Sea Link

Volume 9: Examination Submissions

Document 9.90: Applicant's Response to January Hearing Action Points from Compulsory Acquisition Hearing 1 (CAH1) and Issue Specific Hearing 2 (ISH2) – Deadline 4

Planning Inspectorate Reference: EN20026

Document Ref:	Scale:	Format:	Sheets:	Rev:
FIGURE 1	1:10,000	A3	1	0

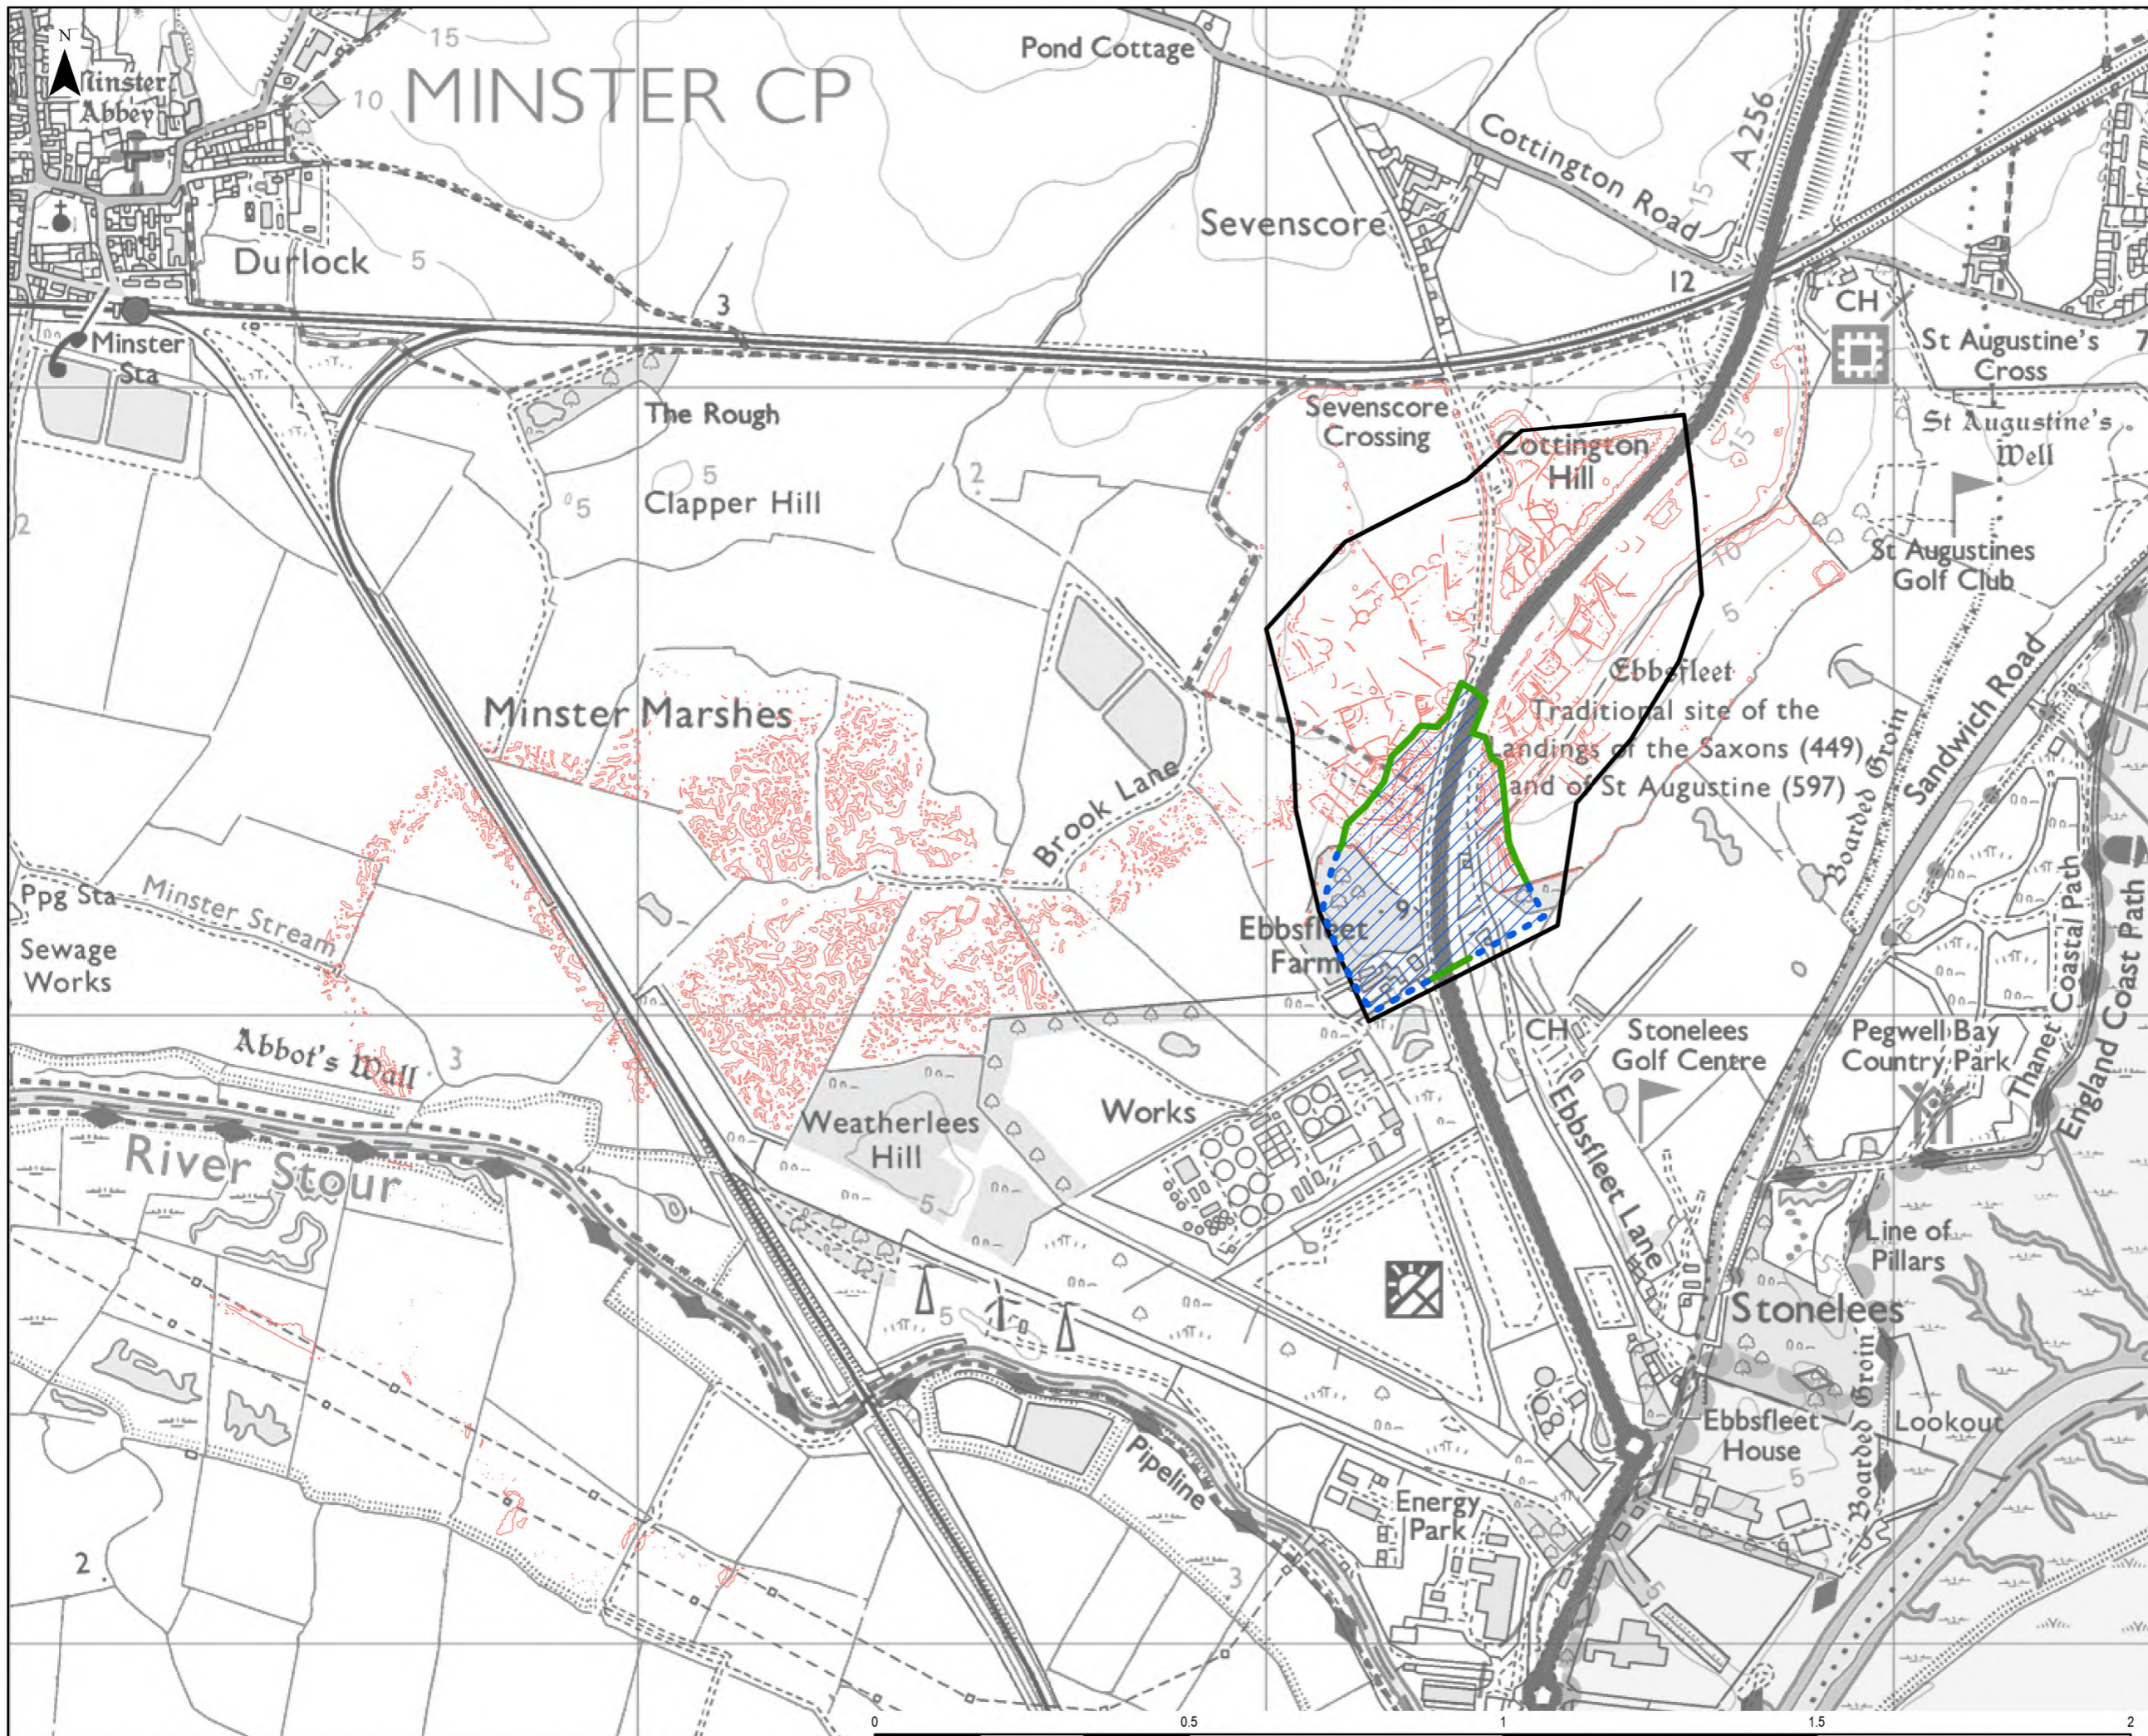
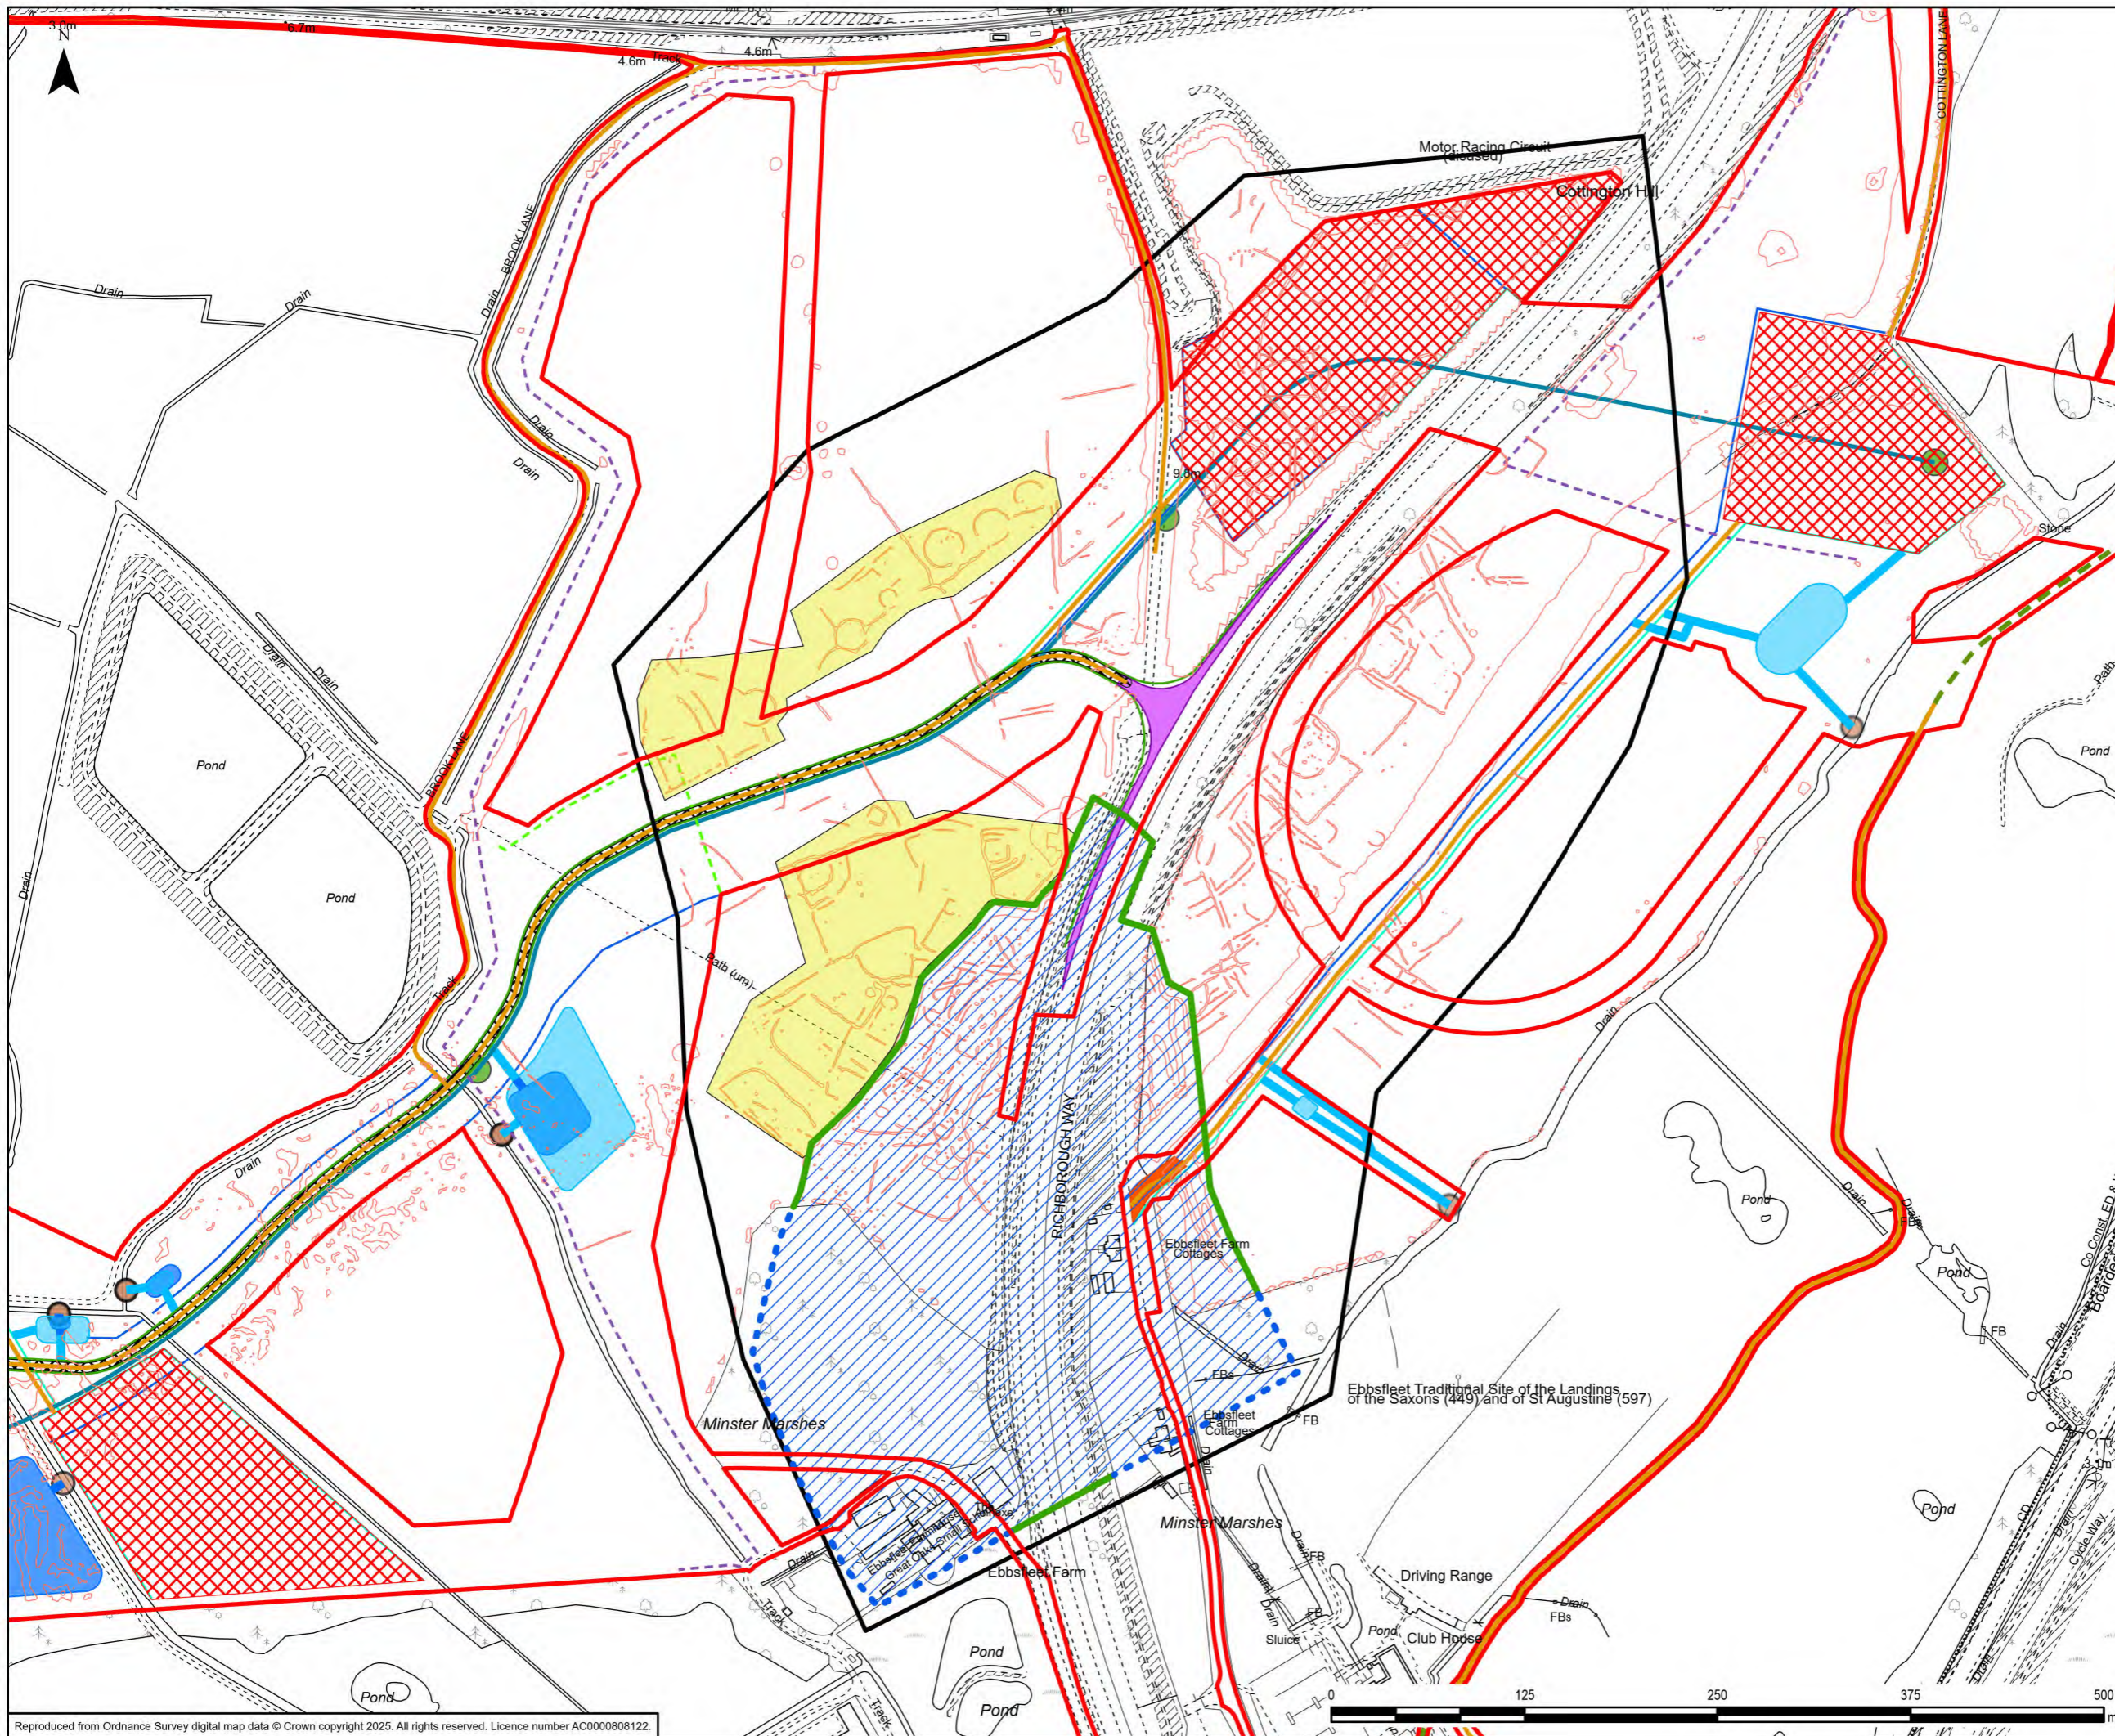
AP56	Agree on a plan to submit showing the extent of the Ebbsfleet Peninsular Multi Period Complex with the proposed order limits, proposed compounds and haul roads overlaid.	The Applicant, in consultation with KCC, has produced two figures. The first shows the extent of the Ebbsfleet Peninsula Complex including the large enclosure possibly associated with Caesar's landings at the southern end of the peninsula (Figure 1 Appendix B) The second figure shows the Ebbsfleet Peninsula complex and large southern enclosure, as well as two areas of Bronze Age barrows and enclosures also considered to be of importance, as well as components of the Kent Onshore Scheme (Figure 2 in Appendix B).	Deadline 4
Traffic and Transport			
AP57	Regarding the Preliminary Cumulative Highway Impact Assessment [APP-142], explain what developments have been included and for what time period or scenario? Furthermore, submit a revised table to also include the worst-case Sea Link construction traffic.	The Applicant has prepared Application Document 9.105 Supplement to the Preliminary Cumulative Highway Impact Assessment in Suffolk submitted at Deadline 4, to provide this clarification and to provide a revised set of total cumulative traffic tables including worst-case construction traffic from the Proposed Project as requested. This is based on the worst-case assumption that the construction peaks of all projects fully overlap, which is a scenario that is not expected to arise. This is illustrated by the graph held within Application Document 9.89 Applicant's Written Summaries of Oral Submissions to Issue Specific Hearing 2 submitted at Deadline 4 which the Applicant has since prepared to indicatively show the varying construction peaks of different cumulative schemes in Suffolk, based on the current understanding of when these are expected to occur. This graph and supporting description are also held in Appendix F.	Deadline 4
